Village of Cottage Grove

PLAN COMMISSION

Wednesday, June 10, 2020

RE: **Atwell Suites Hotel – Precise Implementation Plan**

PLANTING PLAN

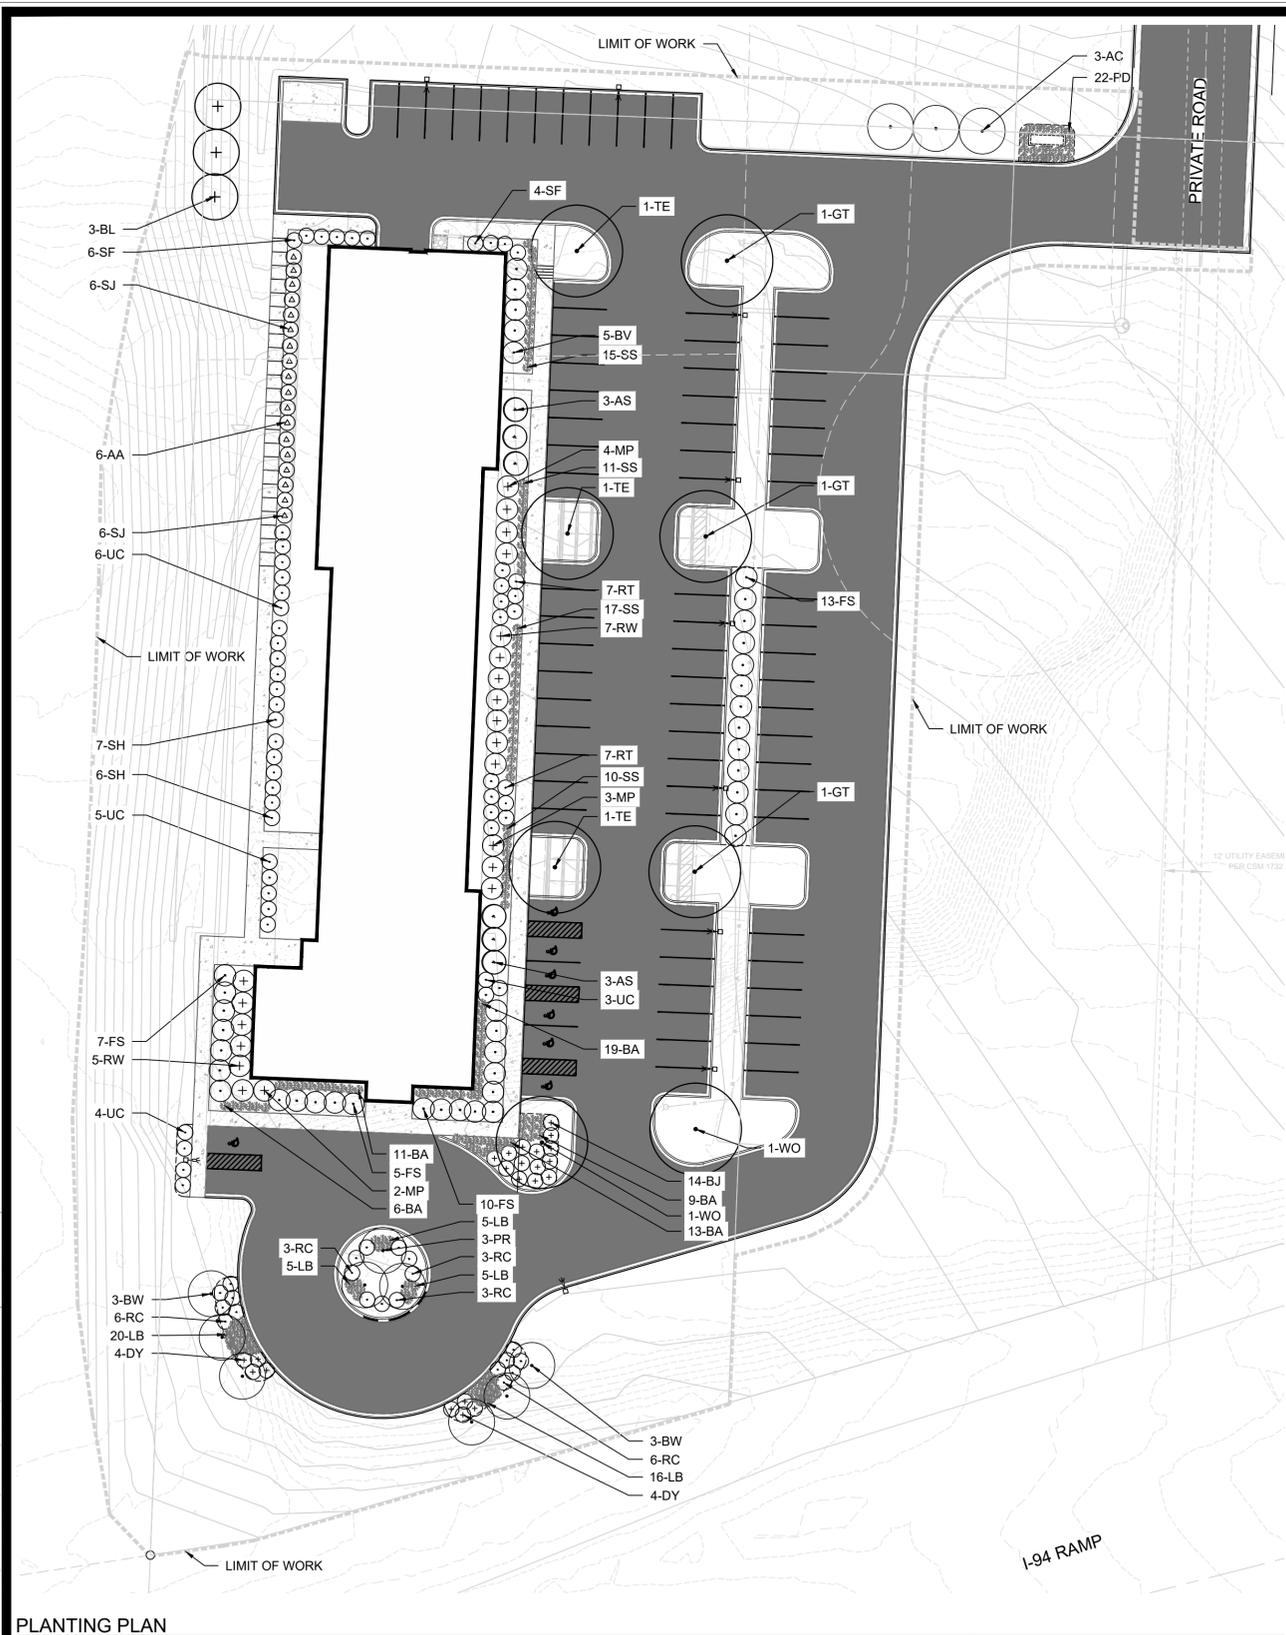
The landscaping plan shows a white oak near the SE corner of the building. Upon maturity white oaks can grow quite tall and as shown it appears that the tree may obstruct views of the building's signature southeast corner. The applicant may wish to consider relocating the white oak to a different location on the site.

ATWELL SUITES		TURNING MOVEMENTS - 46' LADDER TRUCK		VILLAGE OF COTTAGE GROVE, WI	
SNYDER & ASSOCIATES, INC. 		2727 S.W. SNYDER BLVD ANKENY, IOWA 50023 515-984-2020 www.snyder-associates.com		Project No: 119.1084.30	
Project No: 119.1084.30		Sheet FIG 1		Sheet FIG 1

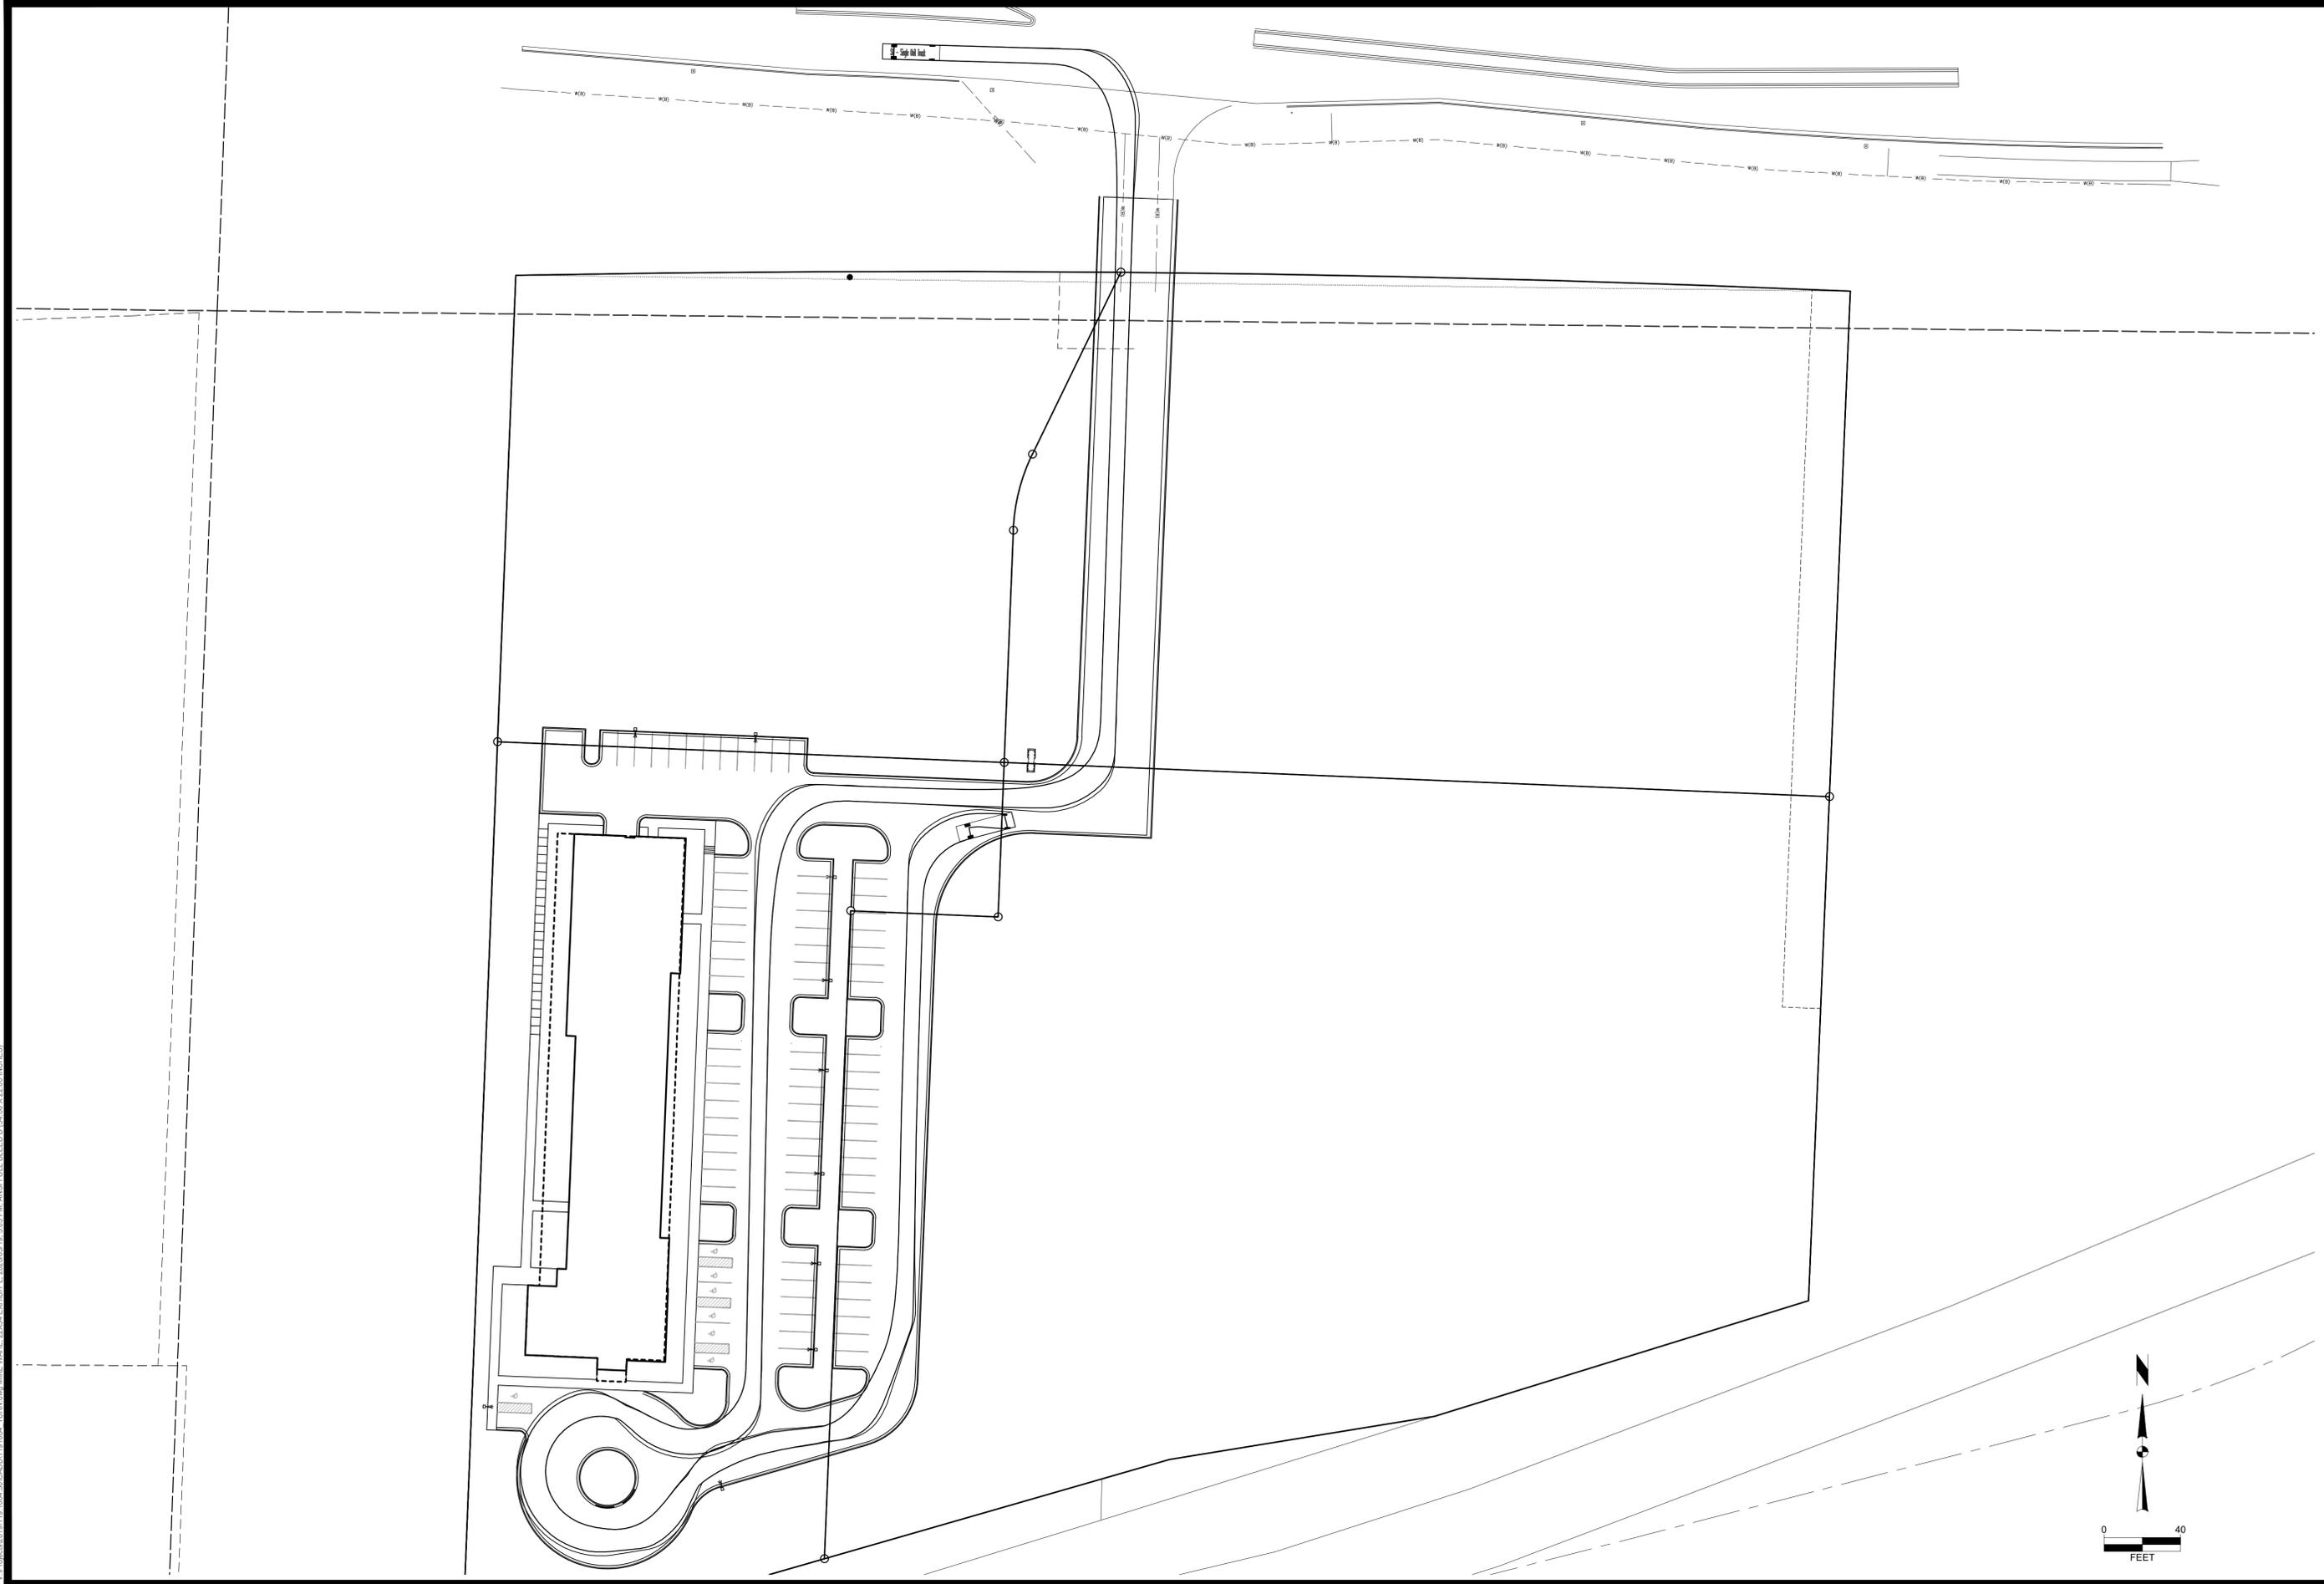
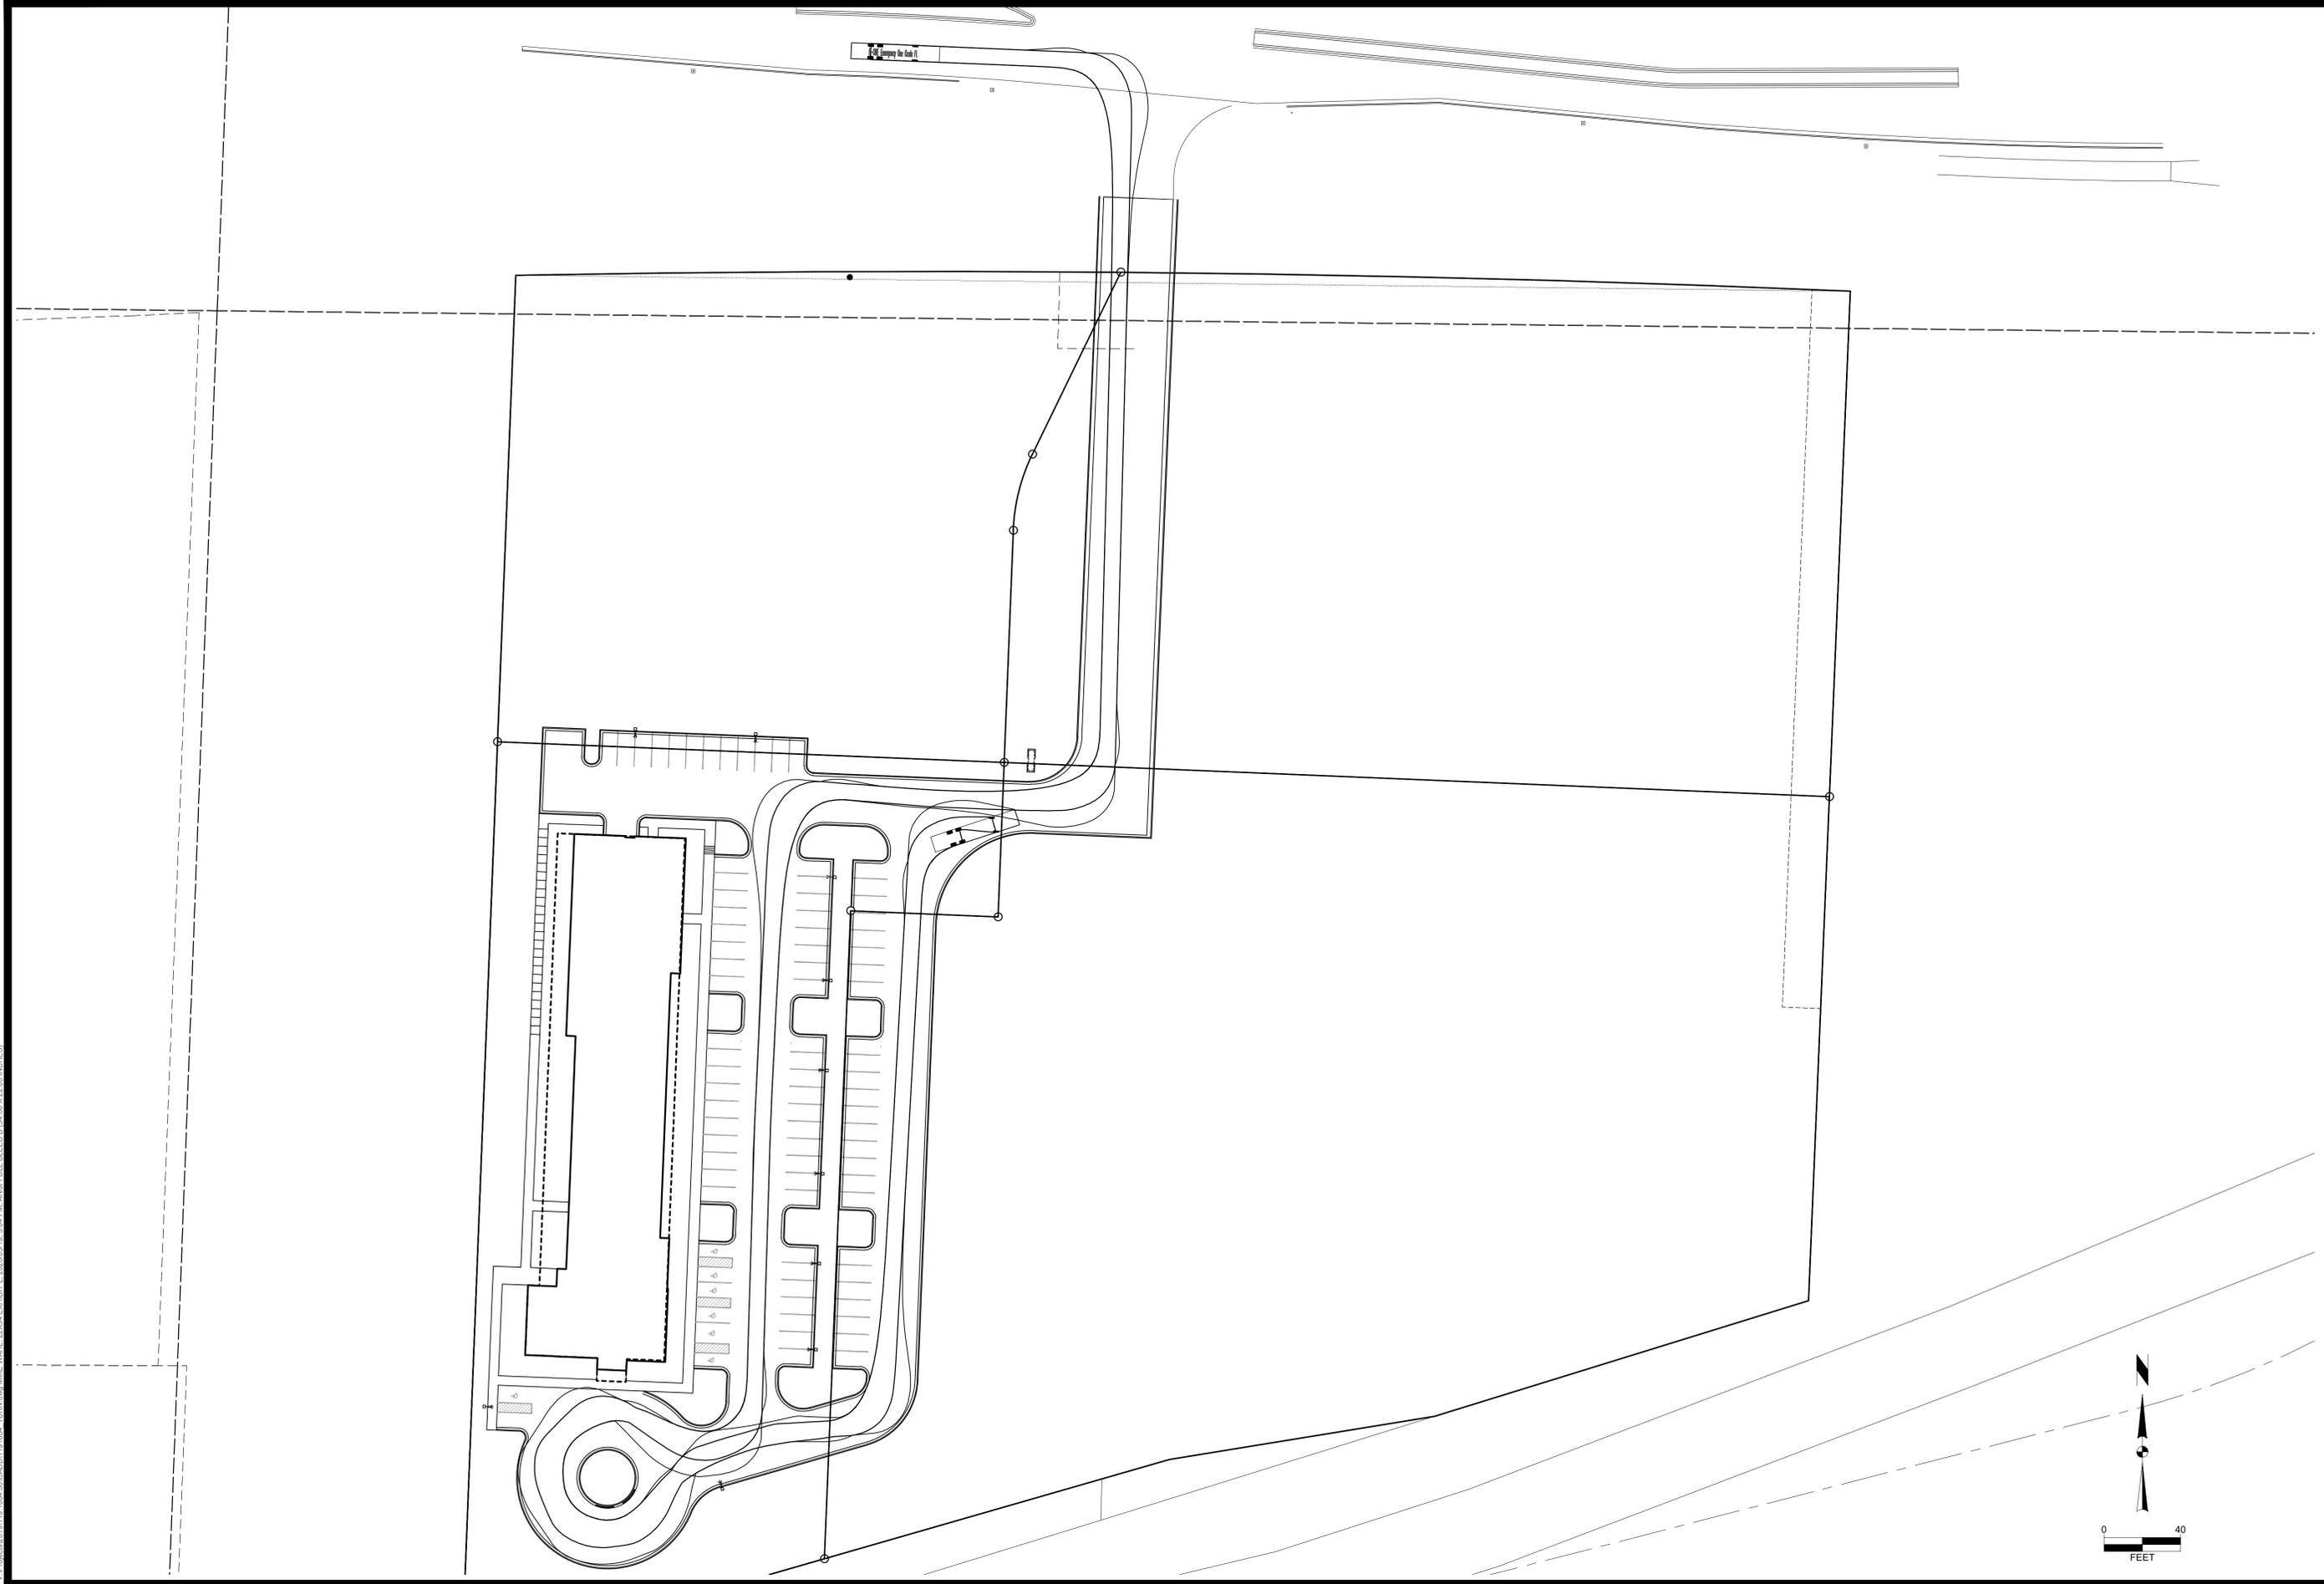
The applicants have provided drawings which verify the parking layout can accommodate the necessary turn radii for a 30' box truck and a 46' fire department ladder truck, fulfilling a condition of GDP approval.
